ADDENDUM NO. 2

WASHINGTON STATE PARKS AND RECREATION COMMISSION
NISQUALLY STATE PARK
WELCOME CENTER & LOOP TRAIL PHASE 3B
NW-C1218C

DATE: August 26, 2025

1 **WELCOME FIGURE FOOTING PLAN**
C3.13 SCALE: 1" = 1'-0"

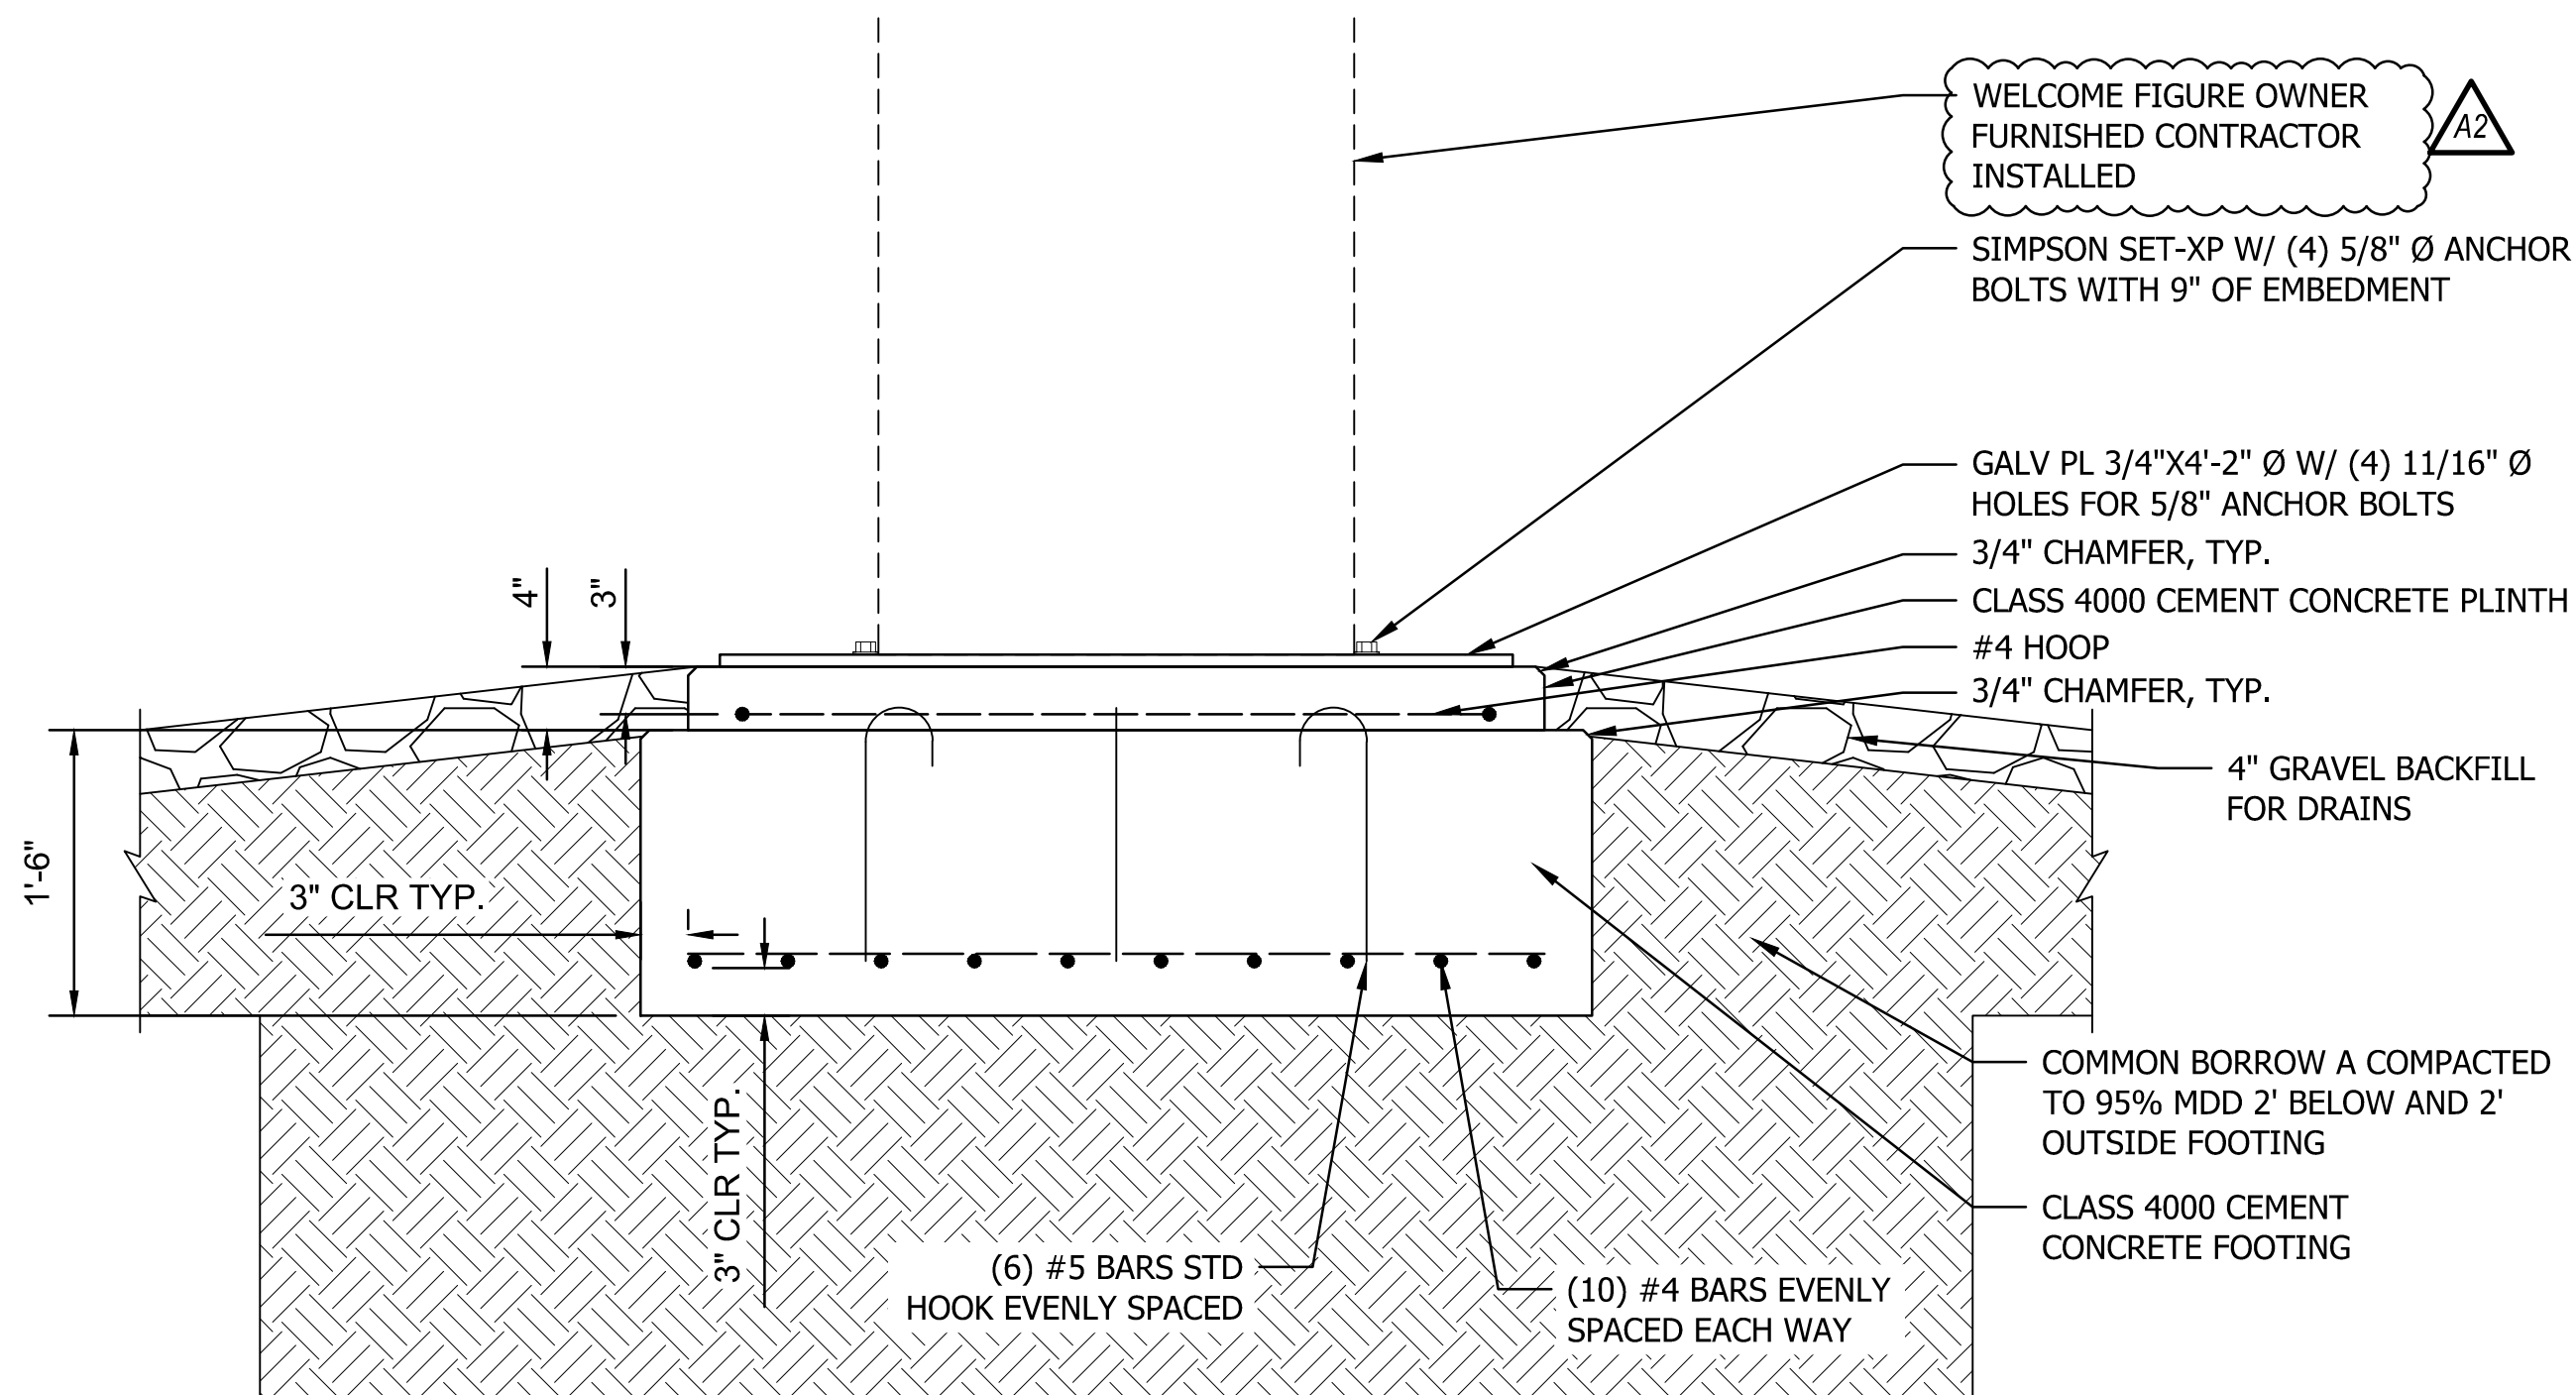
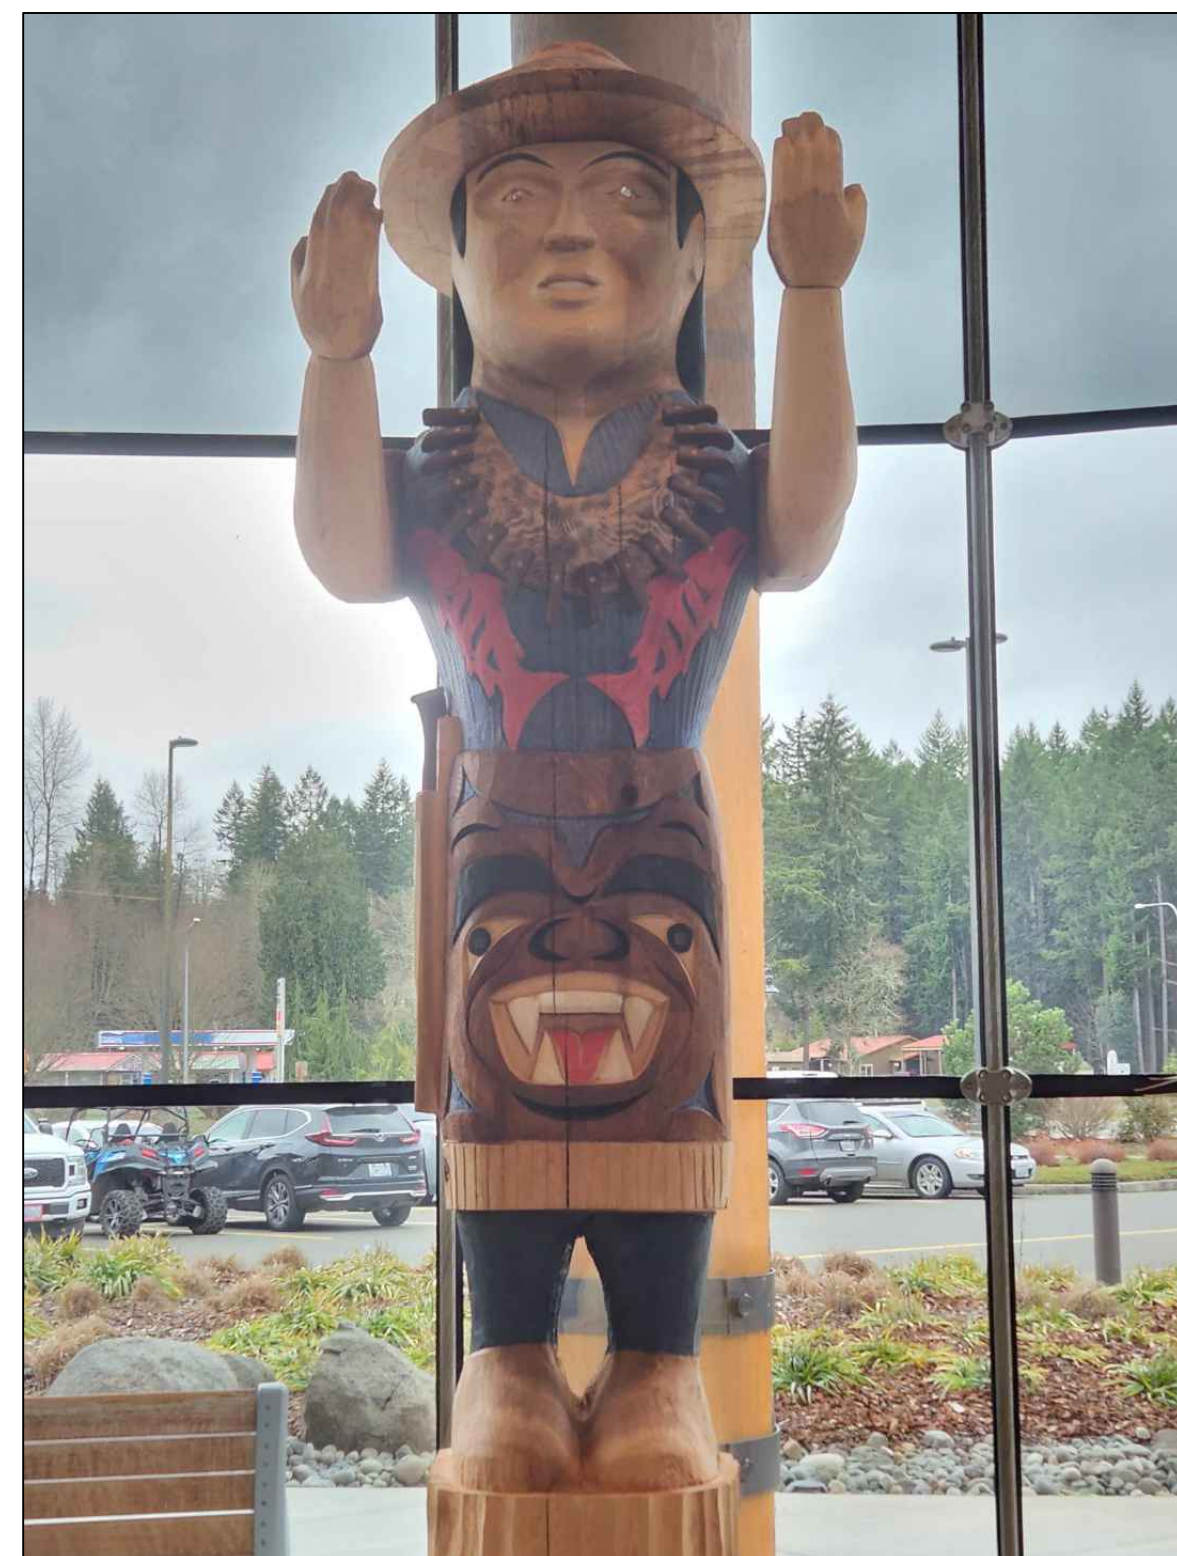
1. Question: Welcome Figure is shown as OFCI on site plan and specifications, but noted to be installed by Owner on C3.13 Detail 2 notes.
Answer: Welcome figure to be OFCI as per site plan and specification.

CAD NO.		
8/22/2025		DATE
		APP.
		INT.
ADDENDUM #2: -ADJUST NOTES TO MATCH SPECIFICATIONS		
ADDENDUM #2		NO.
ACTION	BY	DATE
DESIGNED		
DRAWN		
CHECKED (FIELD)		
CHECKED (HDQTS.)		
REGISTERED STAMP		
WASHINGTON STATE PARKS AND RECREATION COMMISSION		
NISQUALLY STATE PARK		
PHASE 3B WELCOME CENTER AND LOOP TRAIL		
SITE DETAILS - WELCOME FIGURE FOOTING		
C3.13		
SCALE AS SHOWN		
PARKS FILE#

4. OWNER WILL FURNISH FIGURE, CONTRACTOR WILL INSTALL FIGURE.
